What You Told Us

Our Recommendation

Section 3A

Detail Plan 3A

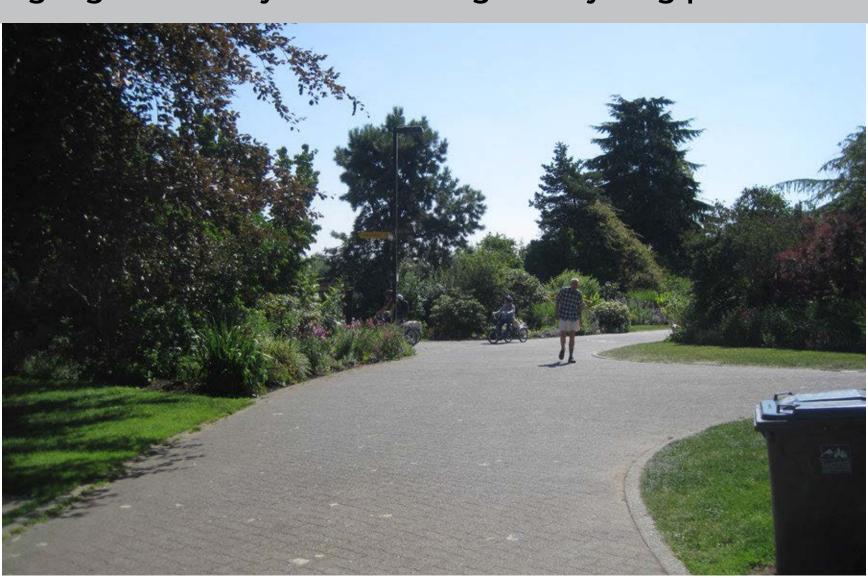
- Widen the pathway through Sutcliffe Park to allow separation. (80% Yes, 9% No)
- Create larger nodes (open public spaces) at entrances to Granville Island. (66% Yes, 13% No)
- The perennial plant beds are highly valued by residents and visitors.
- Replacing/relocating impacted perennial beds in adjacent locations is a reasonable trade-off for a wider pathway.
 (66% Yes, 21% No)
- Designate one of the three paths that connect to Granville Island as a shared walking and cycling route.
 (56% Yes, 23% No)

"Better signage to the Seaside Bypass would be very helpful; perhaps also some alternative connections."

"There should be multiple ways to get onto and off Granville Island by bike."

"Anything you can do to

"The improvements should be careful not to enable faster biking - especially after changes are made to separate pedestrians from bikes."

"Safety is the issue.
Separation is the only solution."

make the Seawall safer for pedestrians would be very much appreciated."

"Maintain the beauty of the Seawall by maintaining the open spaces and beautiful plantings."

"This small section of the Seawall, just before the bridge to the community centre and Alder Bay, is an important place for birds in the spring."

"Ensure the intimacy of the walking path is maintained wherever possible. Avoid widening the path such that it feels like a boulevard."

Recommended Solutions Why? When? Widen pathway and provide painted separation and signage to clearly The landscaping and narrow, curved Winter 2016/17 mark walking and cycling paths. pathway limits visibility in this busy See Detail Plan 3A, Board 3.2 and popular area. Key components of design: • Pathway widened to 6.0m. Affected perennial plant beds relocated to adjacent locations along the path. Painted pavement markings and signage to separate and clearly mark walking and cycling paths.

Widen pathway and provide painted separation and signage to clearly mark walking and cycling paths.
